EXHIBIT C

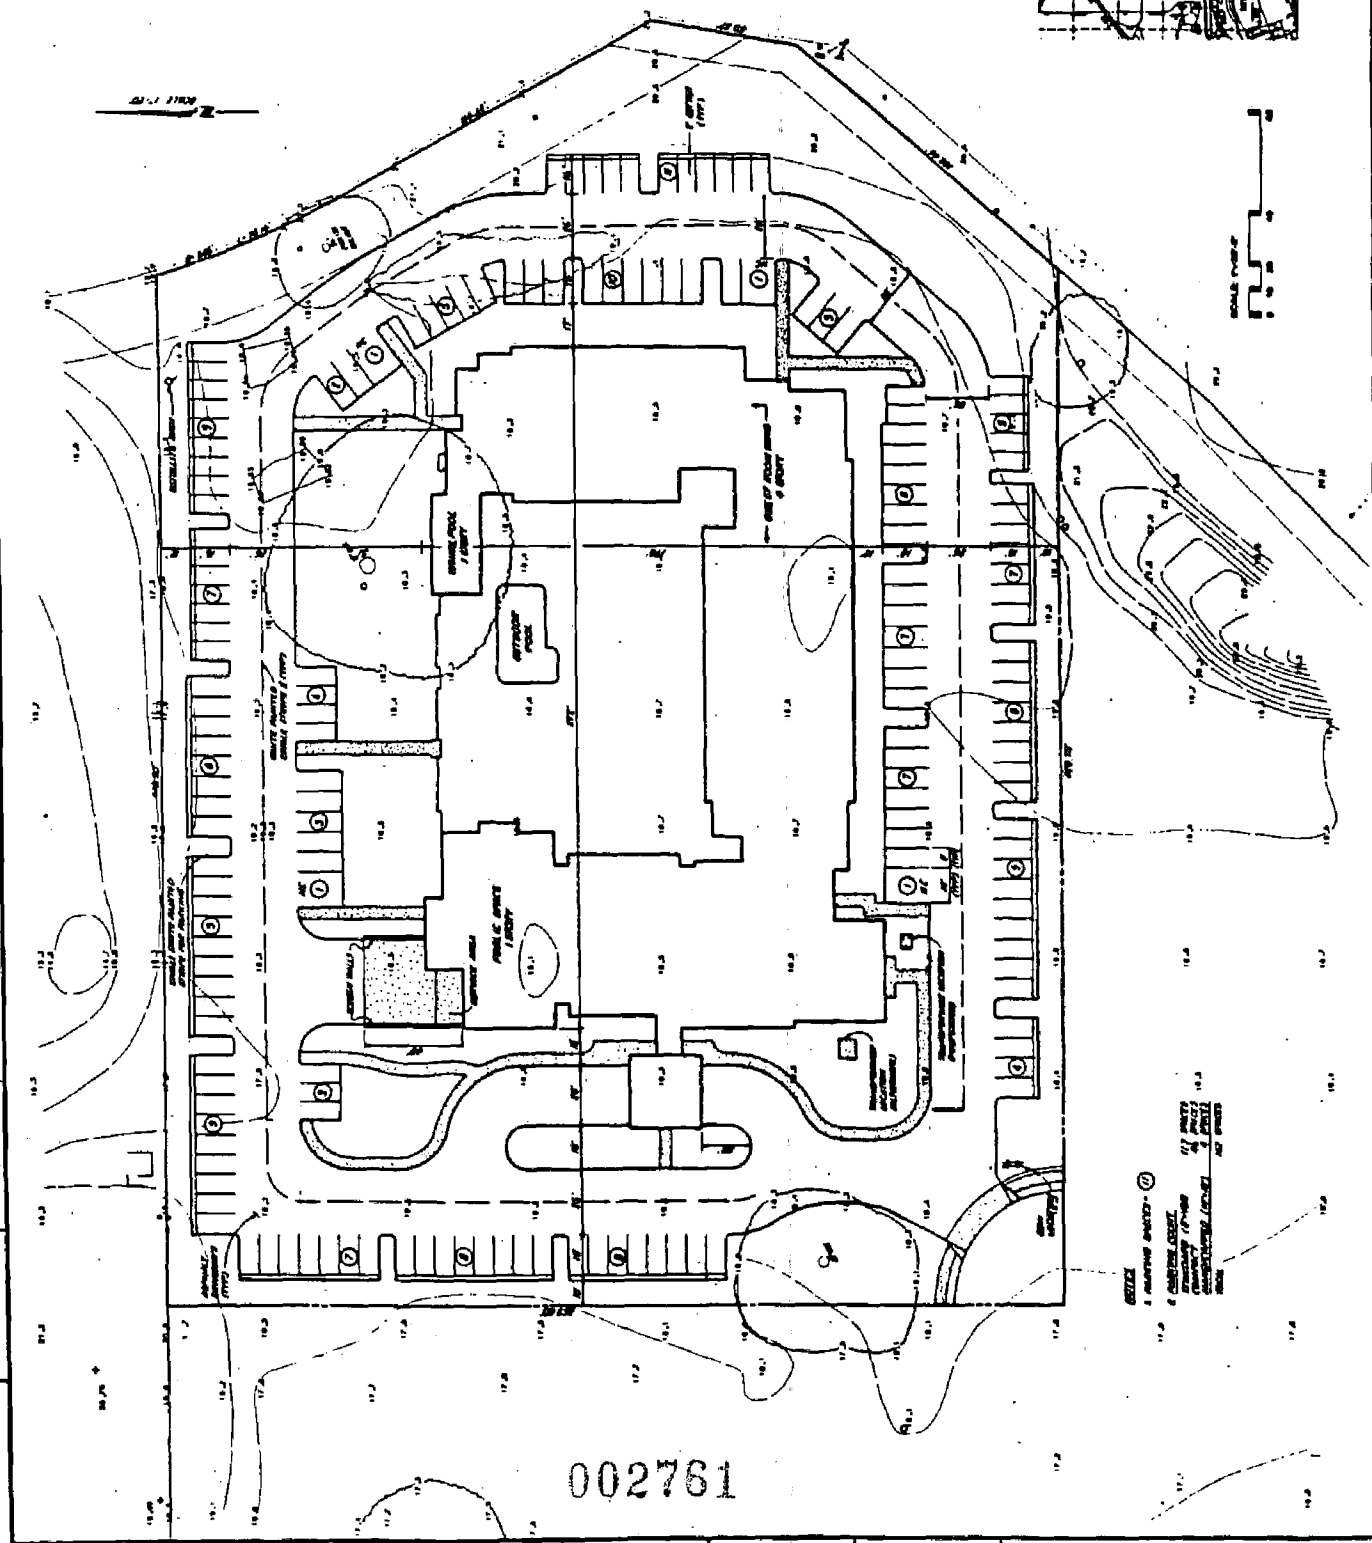
The submitted site plan indicates the required 25-foot landscape setback adjacent to the public street (cul-de-sac entrance) and the 25-foot of landscaping adjacent to the east property line as required for the I-5 scenic corridor (Exhibit C). The submitted landscape plan does not detail landscaping in the required 25-foot front setback (Exhibit D). Due to the limited street frontage on the cul-de-sac it may be difficult to provide the standard three to four foot high undulating berms. Planning staff recommends that the landscaping for this area be detailed on revised landscape plans and that the plans attempt to provide for continuity with the future 25-foot landscaped setbacks on the adjacent parcels.

A satellite dish is indicated on the site plan adjacent to the north property line. Planning staff recommends that the dish be screened from the I-5 freeway and the adjacent property to the north by shrubs and a solid material compatible with the main building (stucco material).

A trash dumpster is not indicated on the site plan. Staff noted, however, on a visit to the existing Marriott Courtyard in Rancho Cordova that an outside dumpster was located in the service area. A trash enclosure which meets Zoning Ordinance requirements will be required for any outside dumpster.

The applicant's original site plan indicated 156 parking spaces. At staff's request the applicant revised the site plan and was able to provide 167 parking spaces on the subject site. The applicant has indicated that the restaurant and lounge would not be advertised to the general public and that the meeting rooms are for guests only.

1. A revised landscape plan shall be submitted for Planning Director review and approval prior to issuance of building permits. The plan shall detail proposed landscaping for the required 25-foot front landscape setback which will be compatible with the landscape setback of adjacent properties. The landscape plan shall adhere to the landscape requirements of the development guidelines and the approved PUD plant list.
2. Plans for the proposed satellite dish including a solid screening structure (stucco material) and landscaping adjacent to the satellite dish shall be submitted for the review and approval of the Planning Director prior to installation of the satellite dish on the subject site.

3. One-hundred sixty-seven (167) parking spaces shall be provided on the subject site. Bicycle parking per Zoning Ordinance requirements shall also be provided.

EXHIBIT E

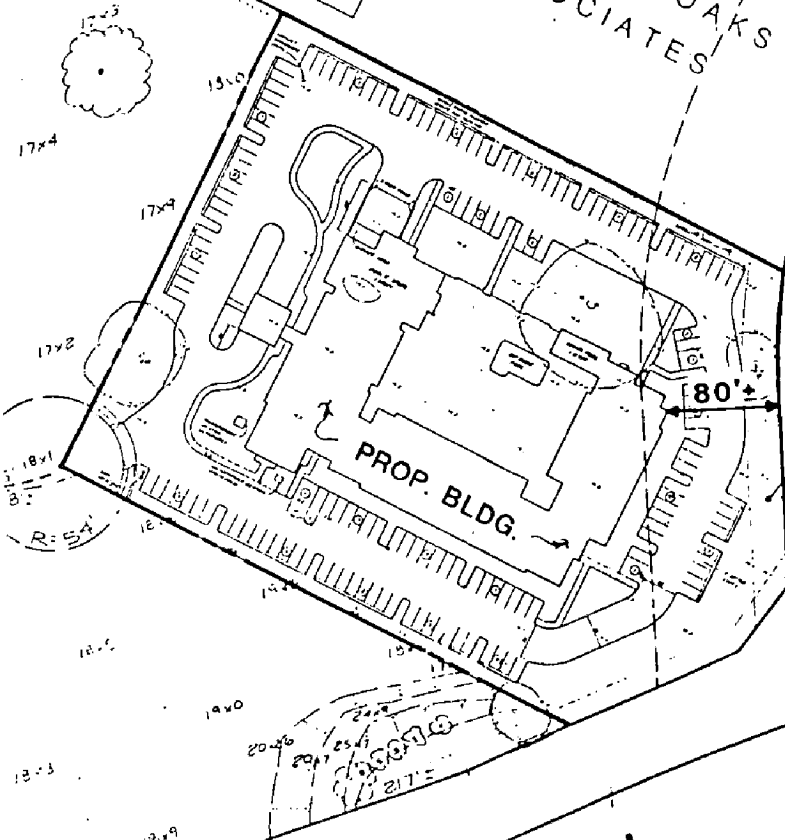
Two large oak trees which have been determined to be significant by the City Arborist are also located on the subject site. The applicant has positioned the Courtyard building and the driveways and parking areas so that these two trees can remain on the site. As a result, a small portion of the subject building is 80 feet from the I-5 on/off ramp (Exhibit E). The PUD Development Guidelines indicate that the building setback from the exterior right-of-way line is to be 100 feet. The proposed building, however, could not be relocated further west on the site unless the one oak tree was removed or the number of parking spaces were reduced. The applicant, therefore is requesting a variance from the development guidelines to reduce the required 100 foot setback for a portion of the building. Due to the physical constraints of the subject site and that the building is within 100 feet of the freeway on/off ramp rather than the main roadway, Planning staff has no objections to the variance request.

- I. Approve the Variance from the Gateway Centre PUD Development Guidelines to locate a hotel/motel/motor lodge building within 100 feet from the freeway right-of-way based upon findings of fact which follow.

3. The variance request is not a special privilege extended to one property owner in that:
 - a. the existing heritage oaks trees on the site make it difficult to revise the site plan to move the structure further to the west and still preserve the oak trees;

- b. a small portion of the building is within 100 feet of the elevated freeway off-ramp rather than the main I-5 roadway;
 - c. a variance would be granted to any other property owner facing similar circumstances.

EXHIBIT H
Elevations

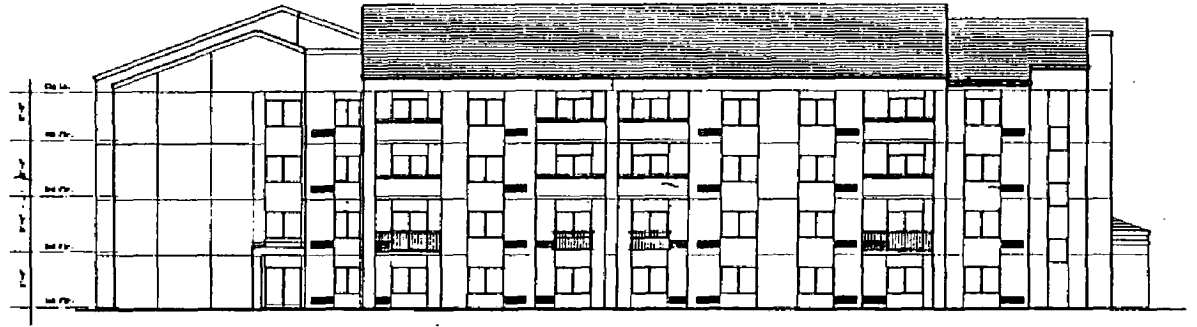
The original elevations submitted to planning staff indicated a flat roof on the building except at the porte cochere which had a pitched roof. Staff felt that a pitched roof design for the entire building would be more complimentary to the structure and compatible with the surrounding office park and multiple family residential to the west. Staff also felt that the exterior elevations presented a box-like structure that was too massive for the area and lacked articulation. In order to resolve these design concerns, Planning staff met with the architect for the Marriott Corporation to discuss the project. As a result of this meeting revised plans which indicate a pitched roof on the structure have been submitted (Exhibit F, G and H) and the Marriott Corporation has indicated that they will make the following revisions to the building elevations:

1. Facade shall be modified to indicate pulled back panels between the flush facade windows and change of color in these areas.
2. Horizontal accent panels shall be placed on other portions of the facade, porte cochere and entrance to building.
3. Color accent band shall be placed at top of building below roof.
4. Wider control joints shall be added at all horizontal locations.
5. All rails, windows and doors shall be color coordinated.

5. The proposed building shall indicate a pitched roof design as indicated by Exhibits F, G and H. The applicant shall make the following revisions to the building elevations subject to Planning Director review and approval prior to issuance of building permits:

- a. The facade shall be modified to indicate pulled back panels between the flush facade windows and a change of color in these areas.
 - b. Horizontal accent panels shall be placed on other portions of the facade, porte cochere and entrance to the building.

- c. Color accent band shall be placed at top of building below roof.
 - d. Wider control joints shall be added at all horizontal locations.
 - e. All rails, windows and doors shall be color-coordinated.
